# Product Change Notification PCN-038\_2018\_4-OMTB1815201 PCBA redesign + manufacturing process change + packaging change + marking change HAS series Additional date codes for PCBA redesign and first date code for process automation (see on pages 2 and 4)

# Based on the JEDEC JESD46 standard (latest release)

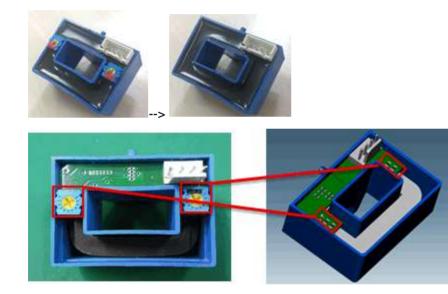
- > Description of the technical changes:
  - 1- PCBA redesign. Remove the 2 potentiometers by laser trimmed resistors. PCBA layout change.

we confirm you that LEM is now producing some of the models listed here above according to the **change 1 – PCBA redesign** and since the **following date codes:**

- → HAS 200-S: date code 719136
- → HAS 200-S/SP50: date code 719172
- → HAS 200-S/SP31: date code 719182
- → HAS 100-S: date code 719250 (07 September 2019)
- → HAS 200-S/SP16: date code 719279 (06 October 2019)
- → HAS 200-P: date code 719292 (19 October 2019)
- → HAS 100-P: date code 719293 (20 October 2019)
